VESSEL: FRV40 CLASS 63m FISHERIES RESEARCH VESSEL

TITLE: DOCKING DRAWING

DWG NO. M282–085–FA04 SH 1

## PLAN 13-C
## BLOCK POSITION #1

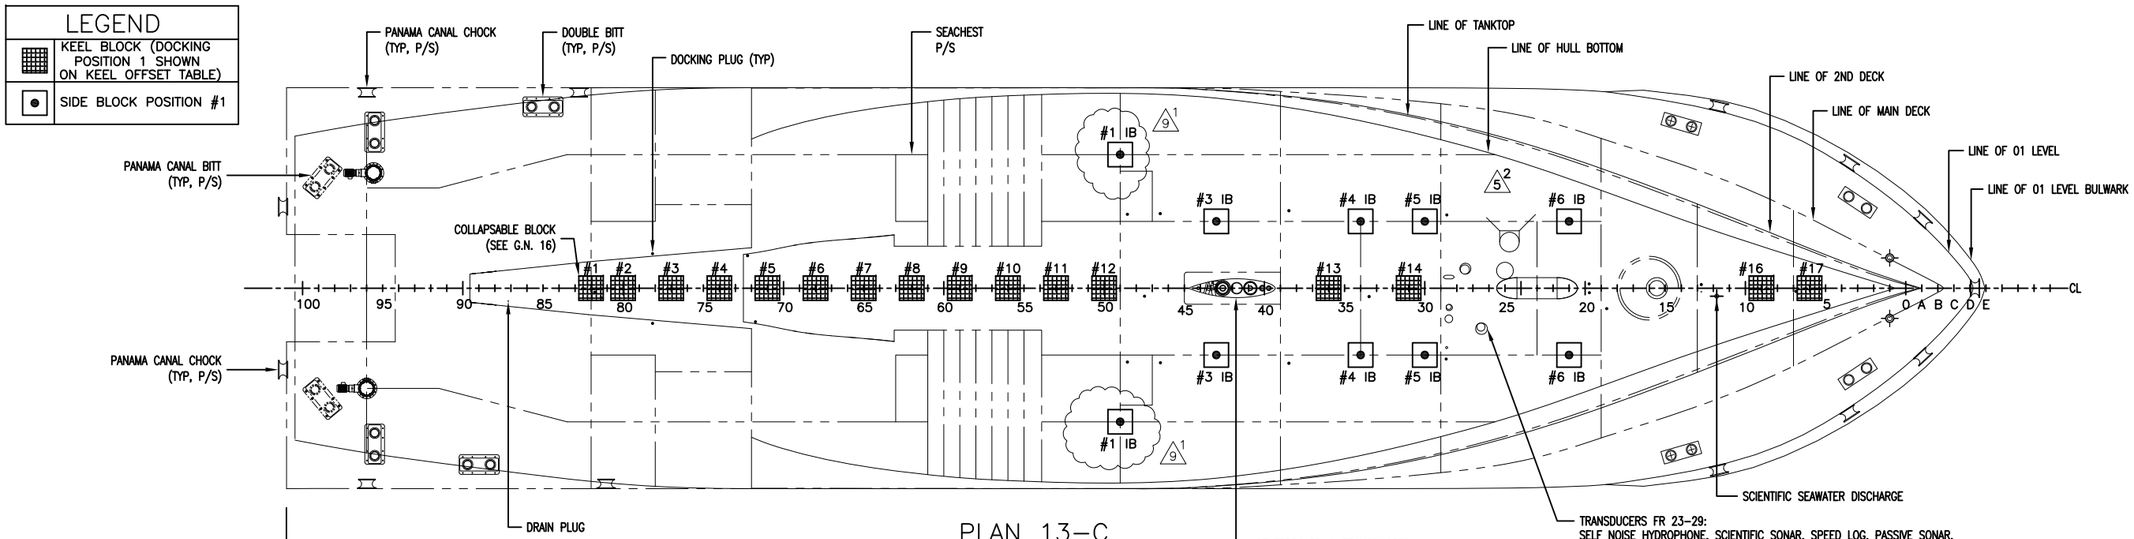
| REV | ZONE | DESCRIPTION | DATE | APPROVED |
|---|---|---|---|---|
| 1 | | 1. SH 2, ELEV. 13–A: ADDED TRANSDUCER APPENDAGE AFT OF KEEL BLOCK #15. CORRECTED ELEVATION CALLOUT FROM "13–C" TO "13–A".<br>2. SH 2, PLAN 13–C: CORRECTED LOCATION AND SHAPE OF TRANSDUCER APPENDAGE. SPLIT KEEL BLOCK #15 TO PORT AND STARBOARD LOCATIONS, 580 OCL, TO CLEAR TRANSDUCER APPENDAGE. CORRECTED PLAN CALLOUT FROM "13–A" TO 13–C".<br>3. SH 3, PLAN 20–A: CORRECTED LOCATION AND SHAPE OF TRANSDUCER APPENDAGE. REVISED KEEL BLOCK #15 TO MATCH BLOCK POSITION #2.<br>4. SH 3, PLAN 20–C: CORRECTED LOCATION AND SHAPE OF TRANSDUCER APPENDAGE.<br>5. SH 6, TABLE FOR KEEL BLOCK NO. 1–17: REVISED BLOCK BEARING PRESSURES FOR BLOCK #15, POSITION 1, FROM 1.755 TO 0.878. REVISED LONGITUDINAL LOCATION AND HEIGHTS FOR BLOCK #15, POSITION 3, TO SUIT RELOCATION TO CLEAR TRANSDUCER.<br>ITEMS 1 – 5 PER ENGINEERING DEVELOPMENT | 5/27/04 RMW | 5/31/04 RG |
| 2 | | 1. SH 1, GENERAL NOTES: ADDED GENERAL NOTES 15 AND 16.<br>2. SH 2, ELEVATION 13–A: REVISED LOCATION OF SONAR TRANSDUCER FROM FRAME 25 TO FRAME 23. DELETED KEEL BLOCK #15.<br>3. SH 2, PLAN 13–C: REVISED LOCATION OF SONAR TRANSDUCER FROM FRAME 25 TO FRAME 23; RENAMED INBOARD BLOCK #3 TO #4 AND ADDED NEW INBOARD BLOCK #3; ADDED NOTE REGARDING OPTIONAL USE OF OUTBD BLOCKS 1–3 P/S.<br>4. SH 3, PLAN 20–A: REVISED LOCATION OF SONAR TRANSDUCER FROM FRAME 25 TO FRAME 23; RENAMED INBOARD BLOCK #3 TO #4 AND ADDED NEW INBOARD BLOCK #3; ADDED NOTE REGARDING OPTIONAL USE OF OUTBD BLOCKS 1–3 P/S; ADDED REFERENCE TO G.N. 15 TO KEEL BLOCK #1 AND OUTBD BLOCK #1<br>5. SH 3, PLAN 20–C: REVISED LOCATION OF SONAR TRANSDUCER FROM FRAME 25 TO FRAME 23; RENAMED INBOARD BLOCK #3 TO #4 AND ADDED NEW INBOARD BLOCK #3; ADDED NOTE REGARDING OPTIONAL USE OF OUTBD BLOCKS 1–3 P/S;<br>6. SH 5, TABLES FOR SIDE BLOCK POSITION 1– 3: REVISED BEARING PRESSURES PER BLOCK TO SUIT KEEL BLOCK 15 DELETION; PROVIDED OPTION TO USE OUTBOARD BLOCKS 1 THRU 3 EXCEPT AS NOTED.<br>7. SH 6, TABLE FOR KEEL BLOCK 1–17: DELETED KEEL BLOCK 15 FROM TABLE TO CLEAR TRANSDUCER INTERFERENCE; ADDED REFERENCES TO GN 15 AND 16 TO KEEL BLOCK 1; REVISED BEARING PRESSURES PER TO SUIT KEEL BLOCK DELETION.<br>ITEMS 1 – 7 PER M282 REWORK #701–0002 | 7/15/04 RMW | 7/16/04 RG |
| 3 | | 1. SH 2, PLAN 13–C: DELETED ALL OUTBOARD SIDE BLOCKS; RELOCATED INBOARD SIDE BLOCK #3 FROM 27 TO FRAME 30.<br>2. SH 3, PLAN 20–C: DELETED ALL OUTBOARD SIDE BLOCKS EXCEPT FOR OUTBLOCK #1; RELOCATED INBOARD SIDE BLOCK #3 FROM 23 TO FRAME 27.<br>3. SH 3, PLAN 20–A: DELETED ALL OUTBOARD SIDE BLOCKS EXCEPT FOR OUTBLOCK #1; ADDED INBOARD SIDE BLOCK #5 AT FRAME 19, 1587 OCL.<br>4. SH 4, SECTION 20–A: DELETED OUTBOARD SIDE BLOCKS.<br>5. SH 4, SECTION 23–A: DELETED OUTBOARD SIDE BLOCKS.<br>6. SH 5, SIDE BLOCK POSITION NO. 1 TABLE: DELETED OUTBOARD BLOCKS 1 THRU 6; CHANGED LOCATION OF INBOARD BLOCK #3; REVISED BEARING PRESSURES TO SUIT NEW BLOCK ARRANGEMENT; CORRECTED BLOCK HEIGHTS; ADDED BLOCK MIDSPAN HEIGHT.<br>7. SH 5, SIDE BLOCK POSITION NO. 2 TABLE: DELETED OUTBOARD BLOCKS 2 THRU 6; CHANGED LOCATION OF ALL INBOARD BLOCKS; REVISED BEARING PRESSURES TO SUIT NEW BLOCK ARRANGEMENT; CORRECTED BLOCK HEIGHTS; ADDED BLOCK MIDSPAN HEIGHT.<br>8. SH 5, SIDE BLOCK POSITION NO. 3 TABLE: DELETED OUTBOARD BLOCKS 2 THRU 6; CHANGED LOCATION OF ALL INBOARD BLOCKS; REVISED BEARING PRESSURES TO SUIT NEW BLOCK ARRANGEMENT; CORRECTED BLOCK HEIGHTS; ADDED BLOCK MIDSPAN HEIGHT.<br>9. SH 6, TABLE FOR KEEL BLOCK: REVISED BEARING PRESSURES TO SUIT NEW BLOCK LAYOUTS.<br>ITEMS 1 – 9 PER M279 TRIAL CARD 1 B 001 OP 01 (M279). | 9/23/04 RMW | 10/29/04 RMW |

| REV | ZONE | DESCRIPTION | DATE | APPROVED |
|---|---|---|---|---|
| 9 | 13-C<br><br>VAR<br><br>26-C<br>VAR<br>56-D | 1. SH 2. BLOCK POS. #1 (PLAN 13-C) – REMOVED #2 IB, MOVED #1 IB TO FR. 49 @ 5000 OCL.<br><br>2. SH 3. BLOCK POS. #2 (PLAN 21-C) – REMOVED #2 IB, MOVED #1 IB TO FR. 44 @ 5000 OCL. BLOCK POS. #3 (PLAN 21-A) – REMOVED #2 IB, MOVED #1 IB TO FR. 49 @ 5000 OCL.<br><br>3. SH 4. ADDED SECTION VIEW OF FR. 49 TO REFLECT CHANGE.<br><br>4. SH 5. UPDATED SIDE BLOCK OFFSETS TABLES TO REFLECT CHANGES.<br><br>5. SH 6. UPDATED KEEL BLOCK OFFSETS TABLE TO REFLECT CHANGES.<br><br>6. SH 1. ADDED REFERENCE 15 TO REFERENCES TABLE.<br><br>ITEMS 1-6 PER ENGINEERING DEVELOPMENT. | 6/20/11<br>RCH | |
